Dart Aerospace Ltd. Monday, 8/21/2006 2:16:23 PM Date: Kim Johnston User: **Process Sheet** Customer : CU-DAR001 Dart Helicopters Services **Drawing Name** : DOUBLER Job Number : 28280 : 10227 **Estimate Number** : NIA-P.O. Number **Part Number** : D2151 S.O. No. : NA : 8/21/2006 **Drawing Number** : D2151 REV. A This issue Prsht Rev. : N/A **Project Number** NA : MACHINED PARTS First Issue Type **Drawing Revision** : 26800 Previous Run Material **Due Date** : 8/28/2006 Qtv: Written By Checked & Approved By Comment : Est C 00.10.2 Re-format (mpp 2101) EC Est Rev:D 06-04-28 Manufactured on Water Jet JLM **Additional Product** Job Number: Seq. #: **Machine Or Operation: Description:** M2024T3S040 1.0 2024-T3 .040 sheet Comment: Qty.: 0.0368 sf(s)/Unit Total: 3.6750 sf(s) Material: 2024-T3 (QQ-A-250/4) 0.040" thick Batch: *M19295* (M2024T3S.040) WATER JET FLOW WATER JET 2.0 Comment: FLOW WATER JET 1-Cut as per Dwg D2151 1 66 08.31 Dwg Rev: A Prog Rev: A 2-Deburr if necessary • QC2 3.0 INSPECT PARTS AS THEY COME OFF MACHINE Comment: INSPECT PARTS AS THEY COME OFF MACHINE SEÇOND CHECK 4.0 Comment: SECOND CHECK

FIRST ARTICLE INSPECTION CHECKLIST

| DESIGN B WILLIAMS | DRAWN BY K HAND |

| DESIGN B WILLIAMS | DRAWN BY K HAND | DART AEROSPACE VICTORIA INTERNATIONAL AIRPORT, | T 1, T |
|-------------------|--------------------|--|--------------|
| Bu | By) | D2151 | SHEET 1 OF 1 |

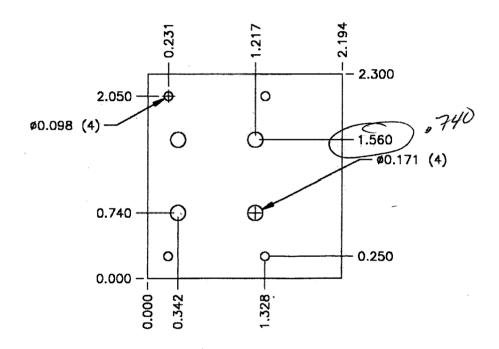
| NCR: | | W | ORK OR | DER NON-CONFORMANC | E (NCR) | | | |
|---------|------|---|--------|-------------------------------------|----------------|-----------|------------|--------------|
| 26 B.31 | 3 | Din, 0.231 on Dug is 0.250", Waterjet program will be updated to match Dug | Cour | Acceptable. DXF to be pelsosted. | M 06 08 3/ | 20.13 | Posen | 10.13 |

| Drawing | Tolerance | Actual | Accept | Reject | Method of | Comments |
|-----------|---------------|----------------|--------|--------|----------------------|----------|
| 0.231 | +/-0.010 | 6.251 | | | | |

| NCR: | | W | ORK OR | DER NON-CONFORMANC | E (NCR) | | | |
|---------|------|---|--------|-------------------------------------|----------------|-----------|------------|--------------|
| | | Spower to match Bus | 2 | | | | 1 | |
